New Basketball Court Markings—Effective with the 2008-09 season

Beginning with the 2008-09 basketball season, a new lane-space mark must be applied to the free throw lane.

BASKETBALL COURT DIAGRAM

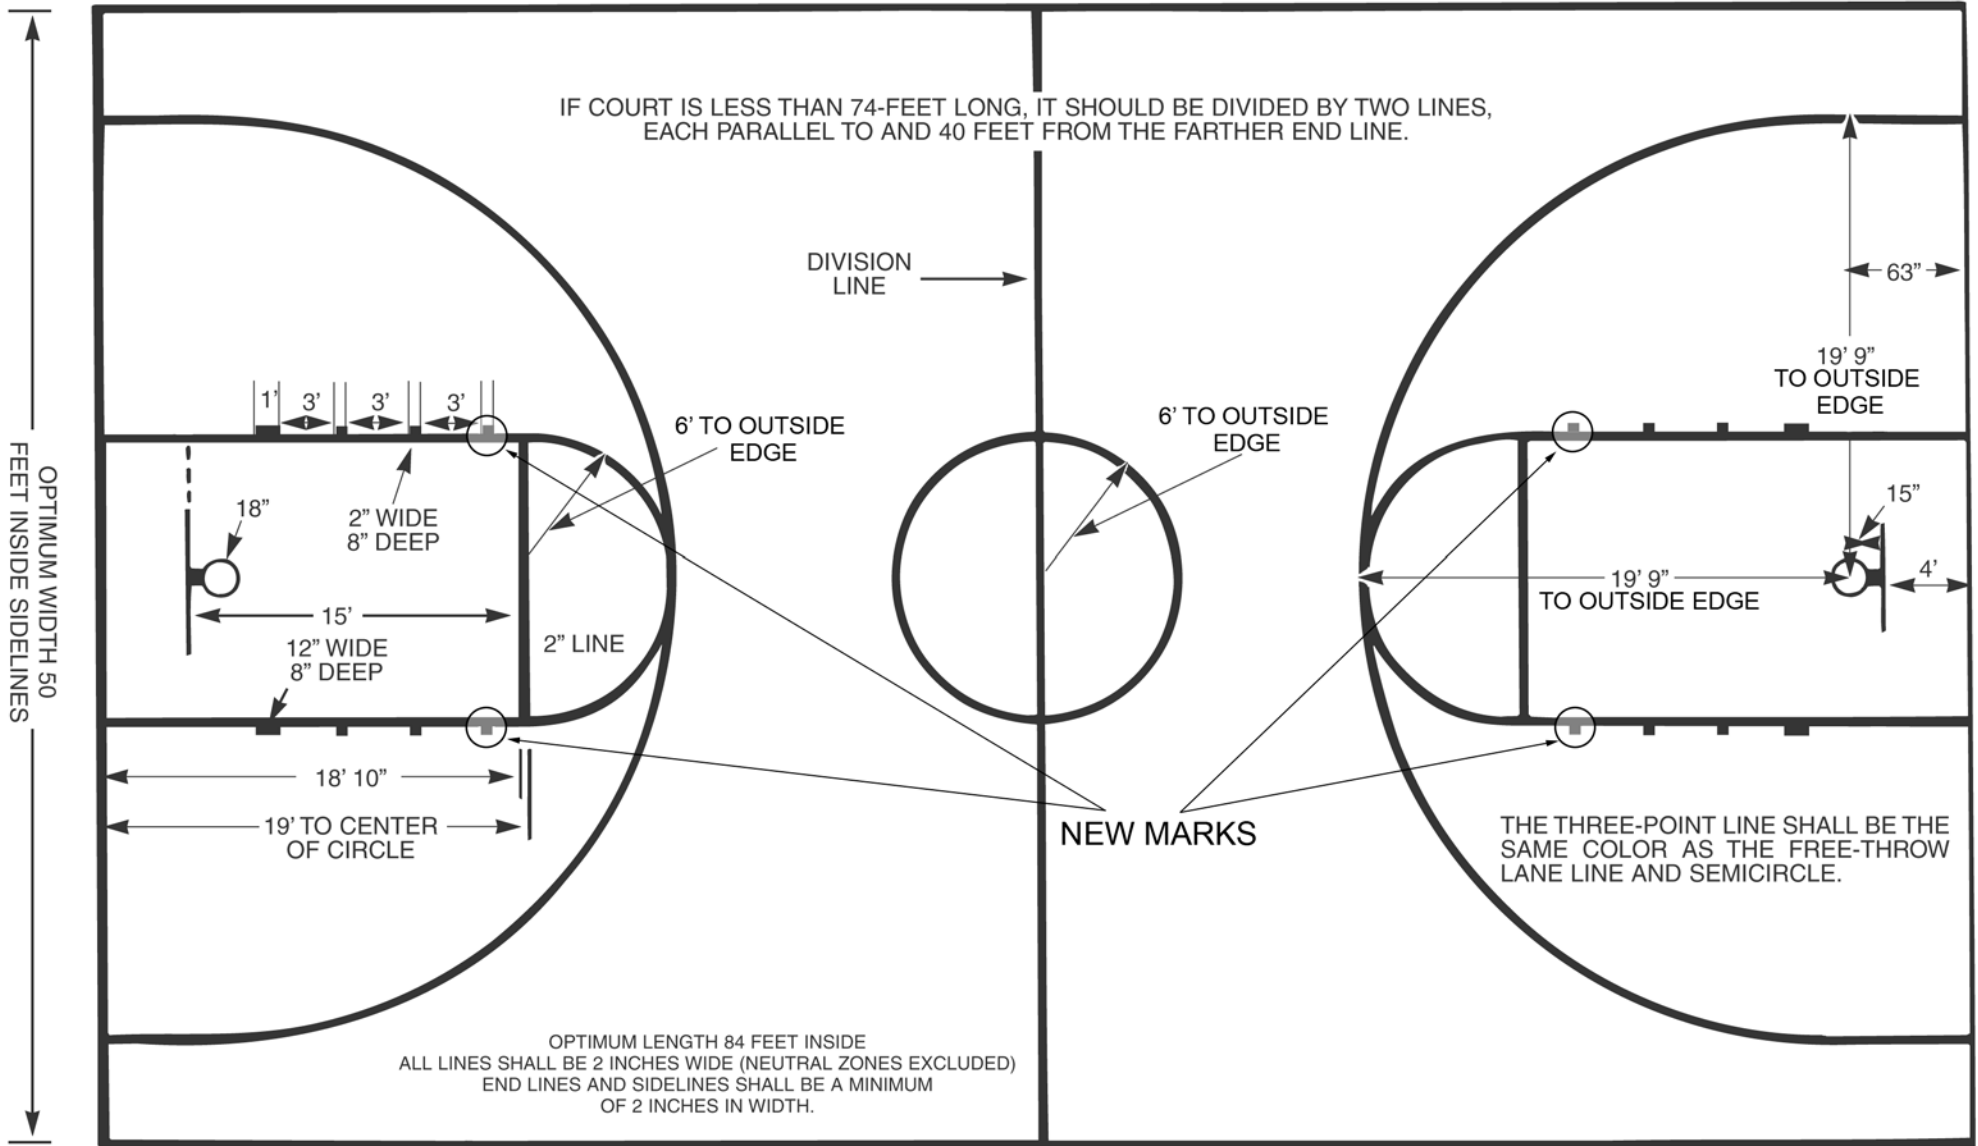
The new court markings come as a result of a rule revision recently approved by the National Federation Basketball Rules Committee that calls for the two marked lane spaces closest to the end line to be vacant during a free throw. This change moves all players up one space on the free throw lane and requires the addition of a new lane space on each side of the free throw line. The change also means that the lane space closest to the end line (*not the block*) is no longer needed.

The attached basketball court diagram shows the location of the new lane space marks which must be 2 inches wide and 8 inches deep and 3-feet from the mark that's closest to the free throw line. We prefer that the marks are painted on the floor. However, floor tape is accepted. Please note that it is not necessary to remove the lane space closest to the end line.

Last, but not least, when adding the new lane space markings make sure that the coaching box is properly marked—a hash mark 14-feet from the baseline and a second hash mark 28-feet from the baseline. These markings are also included on the basketball court diagram.
